TPS2549-Q1 Production Silicon Change List

ABSTRACT

Silicon Bug Description: CDP/SDP Auto-Switch Function is Incorrectly Occurring in CDP Mode

Figure 1. CDP/SDP Auto-Switch Occurs Incorrectly

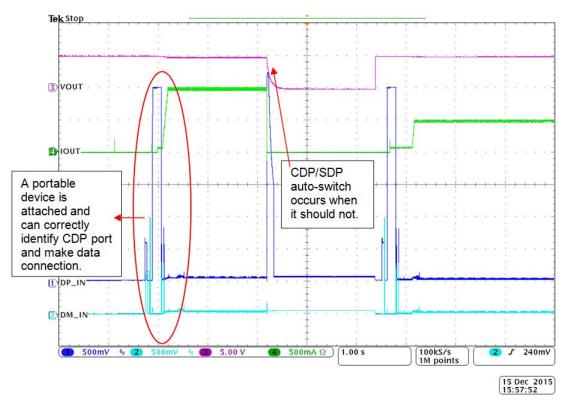
The CDP/SDP auto-switch function in TPS2549-Q1 is meant to occur when a portable device never signals connection and enumerates. However, the silicon bug discovered makes the CDP/SDP auto-switch function incorrectly occur after a portable device has successfully established data communication as Table 1 shows.

The CDP/SDP auto-switch bug will disable fast charging when the TPS2549-Q1 is configured in CDP mode. The bug prevents the portable device from fast charge as the TPS2549-Q1 switches to SDP mode and may also result in data communication loss due to VBUS discharge as shown in Figure 1.

Unfortunately there is no work around where fast charge and data communication are needed in same mode. Use DCP mode to fast charge the device if data communication is not needed, or SDP mode for data communication if fast charging is not needed.

TI has fixed the CDP/SDP auto-switch bug in silicon, see the first page of this change notification for details.
